JLRTB02052NAS2  
**TECHNICAL BULLETIN**  
30 JAN 2023

Rear Doors Difficult To Open

MODEL:	MODEL YEAR:	VIN:	ASSEMBLY PLANT:	APPLICABILITY:
Defender (LE)	2020 Onwards	000431 Onwards	Nitra (Slovakia)	5-Door

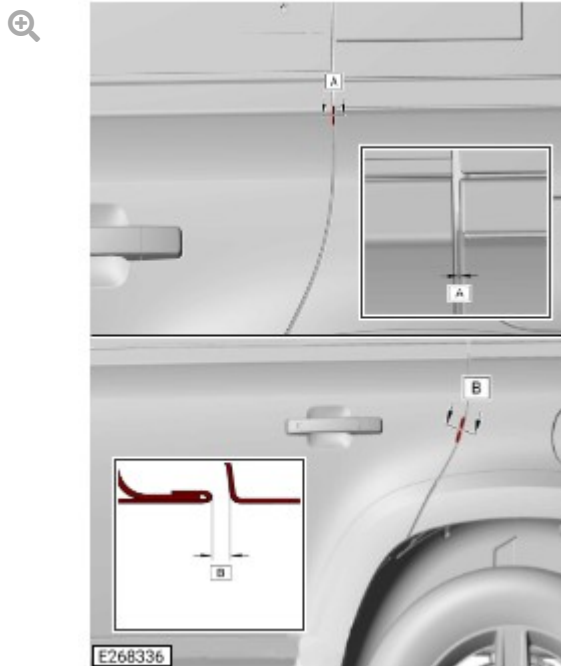
Check the alignment of the rear door(s) in the areas shown in the illustration.

- If the rear door alignment is within tolerance, continue to Service Instruction B.
- If the rear door alignment is out of tolerance, continue to the next step.

SECTION	DESCRIPTION	GAP	PROFILE
A	Rear door to rear quarter	N/A	0.0 ± 0.5 mm
B	Rear door to rear quarter	3.5 ± 0.7 mm	0.0 ± 0.7 mm

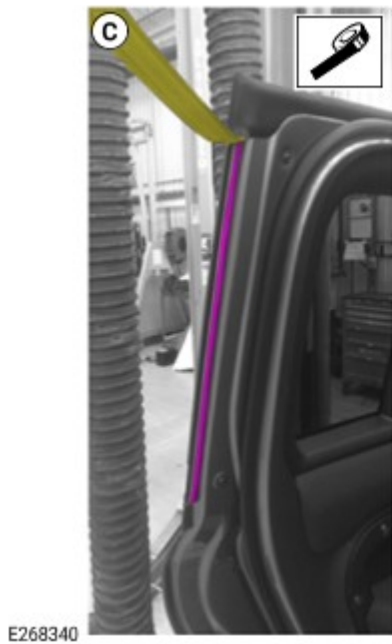
**(A)** Reposition the section of rear door seal shown in the illustration.

**(B)** Make sure the area highlighted in the illustration is clean, dry and free from contamination.

**(C)** Apply the double sided adhesive tape along the seal path on the door frame, as shown in illustration 'C'. Do not remove the protective backing from the double sided adhesive tape at this stage.

**(D)** Install the section of rear door seal removed during step 2.

**(E)** With the rear door seal installed, remove the protective backing from the double sided adhesive tape.

**(F)** Apply firm pressure to the rear door seal to make sure it is adhered to the double sided adhesive tape.

E250069

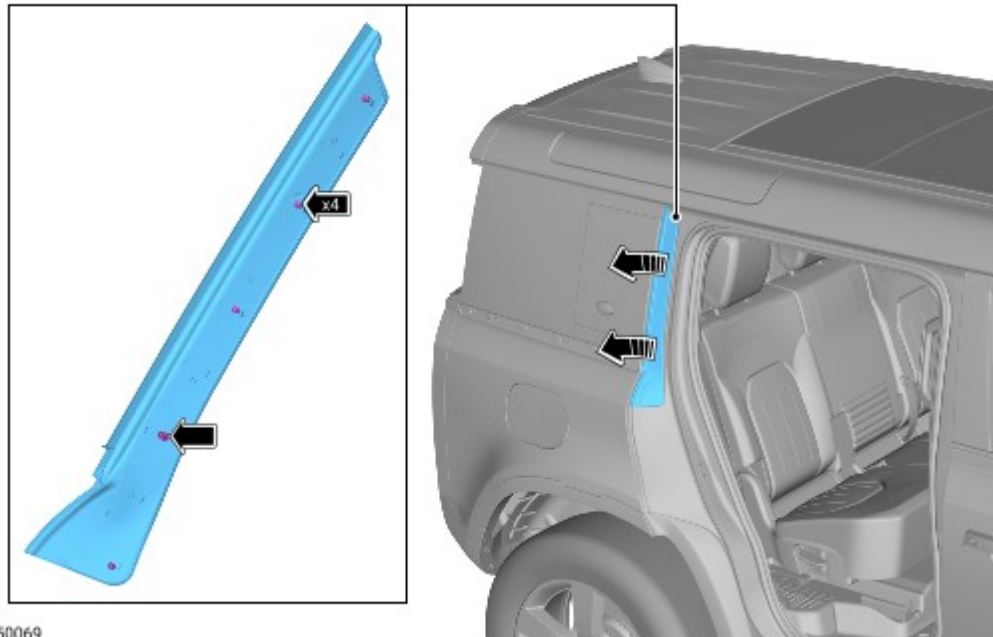
Remove and discard the C-pillar exterior finisher trim.

- Clean the area behind the C-pillar exterior finisher trim.

E268337

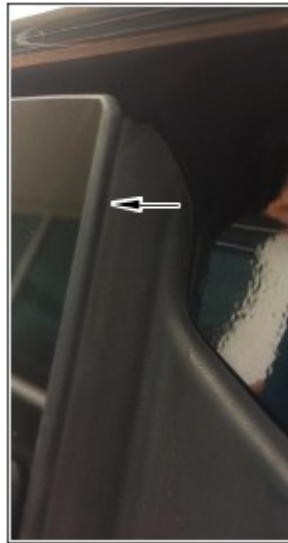
Install the new C-pillar exterior finisher trim.

- Remove the adhesive tape backing.
- **Make sure the C-pillar exterior finisher trim protrudes 1-1.5 mm away from the rear quarter window, as shown in the illustration, before fully securing.**  
The image with the **RED 'X'** shows the C-pillar exterior finisher trim installed incorrectly behind the rear quarter window.  
The image with the **GREEN '✓'** shows the C-pillar exterior finisher trim installed correctly with a 1-1.5 mm protrusion from the rear quarter window.
